**AGENDA FOR THE REGULAR MEETING OF THE
DESIGN REVIEW SUBCOMMITTEE
Wednesday, July 23, 2014**

**A. Tentative Tract Map 14-108/Conditional Use Permit 14-109/Site Plan Permit 14-110/Architectural Permit 14-111, Del Comercio Condos
(Gregg)**

Design Review Subcommittee (DRSC)

SUBJECT: Tentative Tract Map 14-108, Conditional Use Permit 14-109, and Architectural Permit 14-111, Del Comercio Condominiums, a request to consider a ten unit, residential condominium project located at 2717 Calle Del Comercio.

Previous Side Elevation

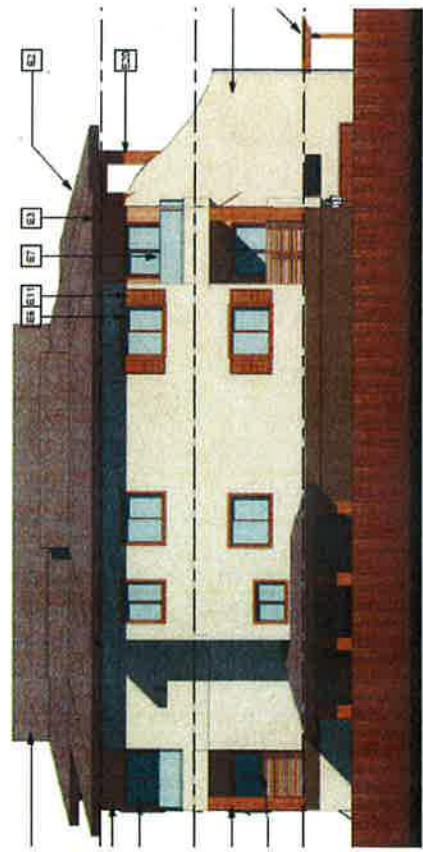
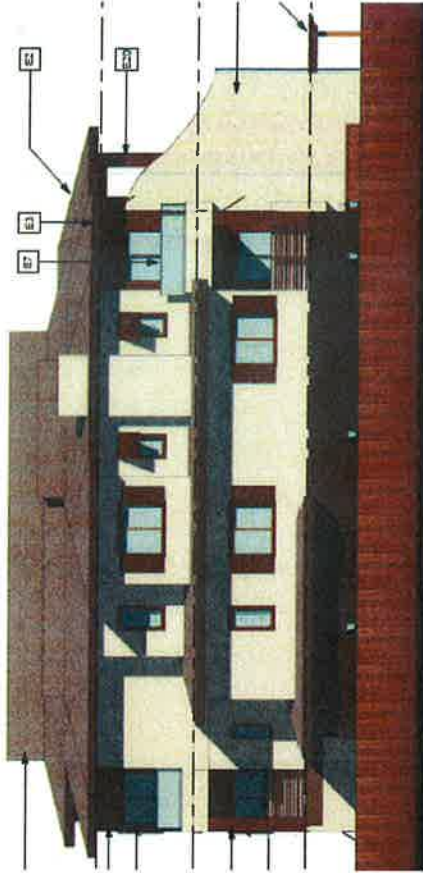
DRSC Concern	Modifications and Project Consistency with Design Guidelines and General Plan
Concerned that the project did not meet <i>Design Guideline II.B.3</i> . Building scale, mass, and form compatible w/ adjacent development.	Modified and Consistent. The applicant created a plane break between the second the third floors on the side elevations. In addition, the third story side elevations were setback and undulation has been provided reducing the scale and mass of the building.

2. Staff recommends additional setback and design features be provided along the sides of the project, particularly on the third level so the building steps down to the adjacent two-story building. This will also help with the mass of the building as previously noted.

Following is a listing of the significant changes to the plans based upon our interpretation of DRSC comments. It is our impression that most of their concerns had to do with additional setbacks desired at the upper level particularly on the side elevations as well as a desire to define the livable units as well. Here is what we did;

- Moved an internal stairway inward to reduce the mass of the third level
- Moved the exterior wall of the living area inward to reduce mass at the third level
- Added a fireplace framing two smaller windows which further defines these units
- Provided more roof steps to provide interest and create undulation
- Added awnings over smaller windows

Previous Front Elevation

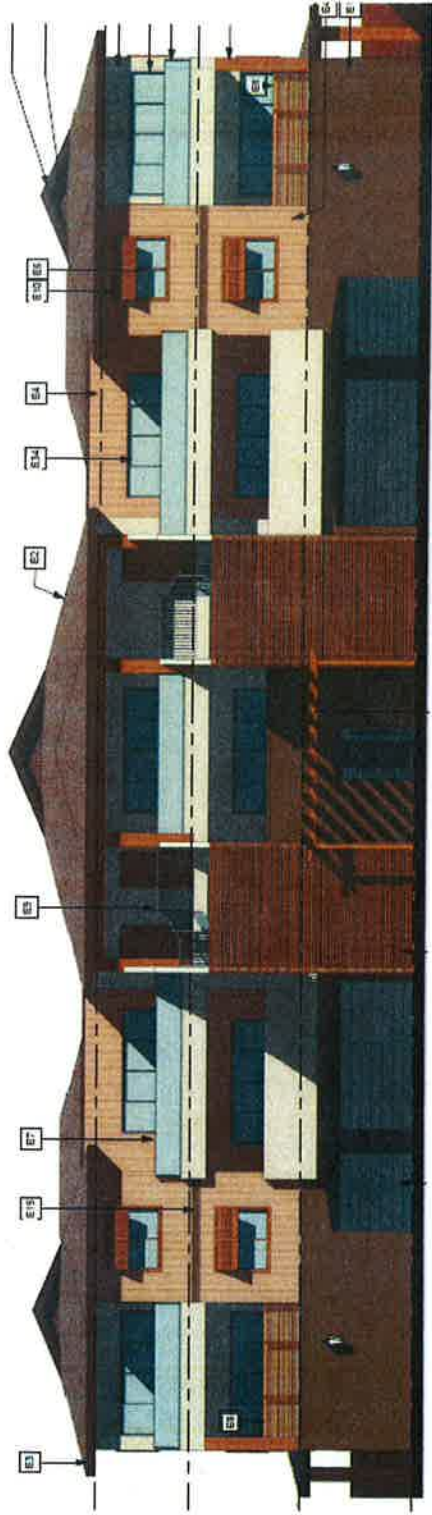
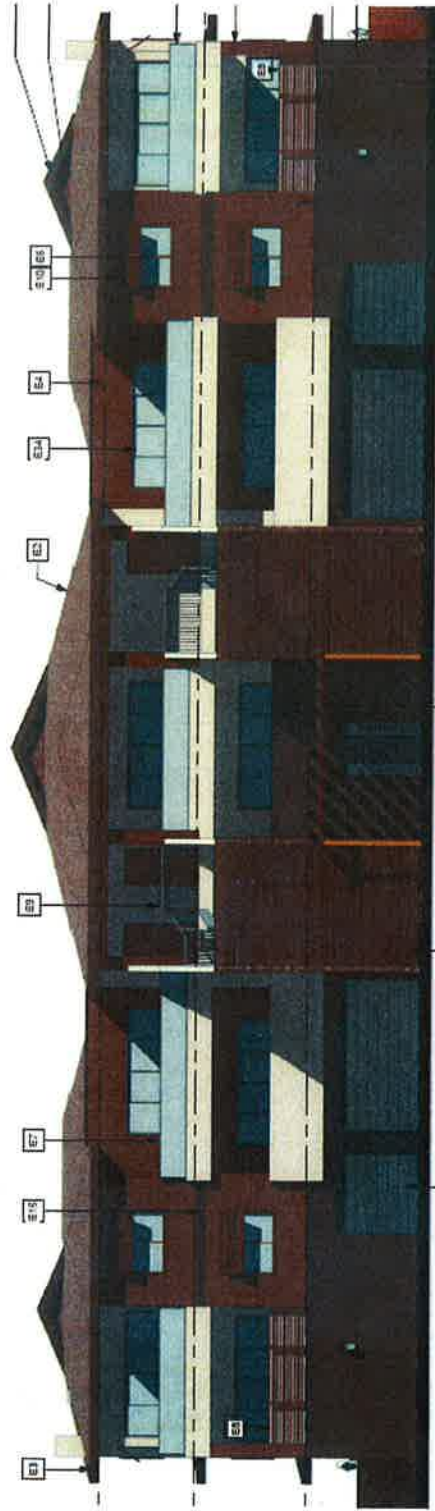
<p>Concern that the project did not comply with <i>Design Guideline II.C.3.b. Reduce the perceived height and bulk of large structures by dividing the building mass into smaller scale components.</i></p>	<p>Modified and Consistent. The applicant clarified at the meeting that the front elevation of the third story has two units with uncovered balconies and the railing is glass. The three dimensional renderings demonstrate the third story is setback which reduces the bulk of the building. The modifications made to the side elevations further reduce perceived scale and mass.</p>
<p>Concern that the project did not comply with <i>Land Use Policy 3.04. Upper Floors.</i> Where buildings over two-stories are allowed, we require building facades above the second floor to be set back from lower, street-facing facades to minimize building height and bulk, pursuant to the Zoning Ordinance, Design Guidelines, and applicable Specific Plans.</p>	<p>Modified and Consistent. The proposed project is set back approximately 22 feet from the front property line. The applicant has utilized open decks at the front and rear elevation on the third floor and setback the third story side elevation to help reduce building height and bulk.</p>

1. To improve individual unit character of the units, staff recommends the third level be stepped back, and two-story features be integrated into the design. In addition, utilizing compatible but varying design features on each of the units will help convey the visual character of the units.

- Revised window openings and patterns
- Added a roof element which accentuates the break between the second and third levels

Previous Rear Elevation

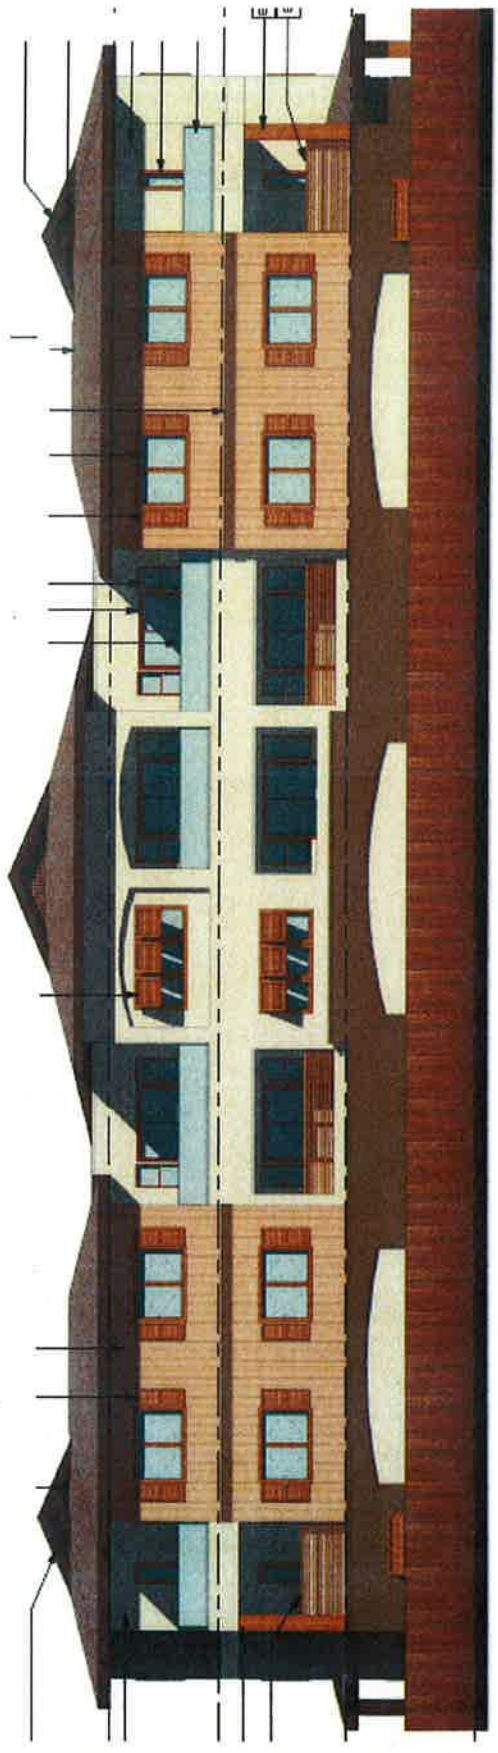
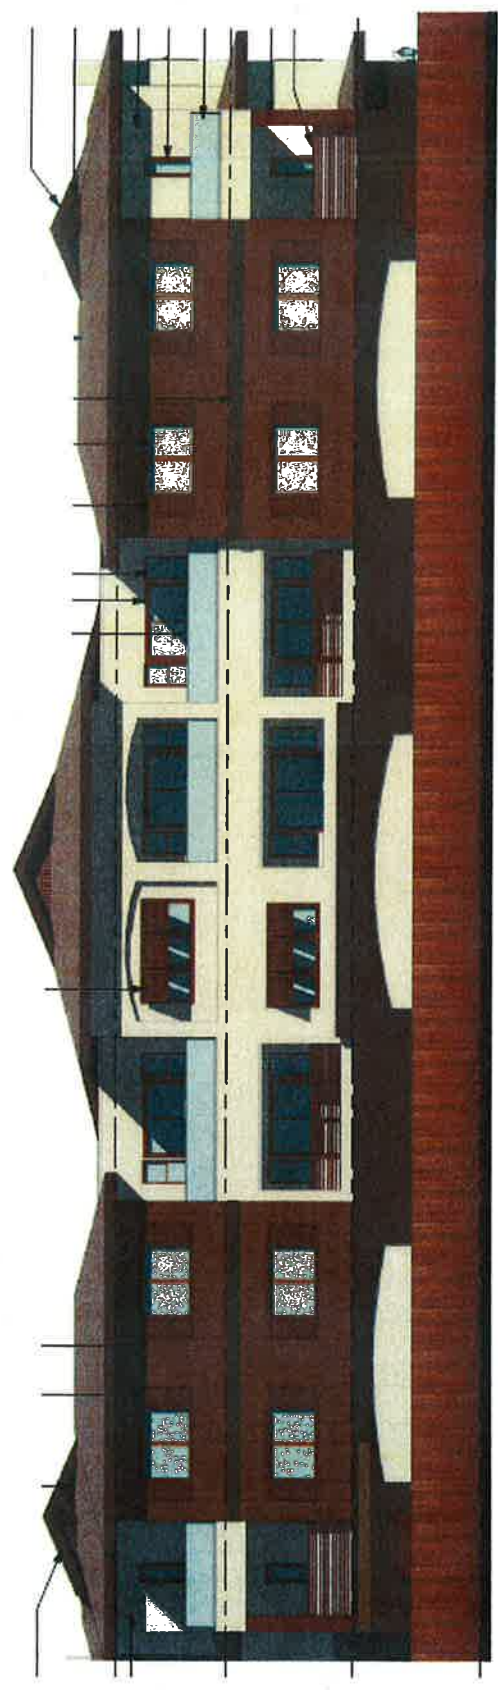
DRSC Concern	Modifications and Project Consistency with Design Guidelines and General Plan
<p>Concern that the project did not comply with <i>Land Use Policy 1.05b, Design all building elevations to convey the visual character of individual units rather than a single, continuous building mass and volume; City of San Clemente Centennial General Plan.</i></p>	<p>Modified and Consistent. The applicant modified the side elevations of the third story, and created visual distinction between the second and the third story units through the use of modified window openings and varied shutter styles. The front and rear elevation were not modified. However, the applicant provided distinction between the units through the use of varied balcony openings (square versus arched) and the use of different materials (wood versus glass railings). Distinction between the units are provided in the individual balconies.</p>
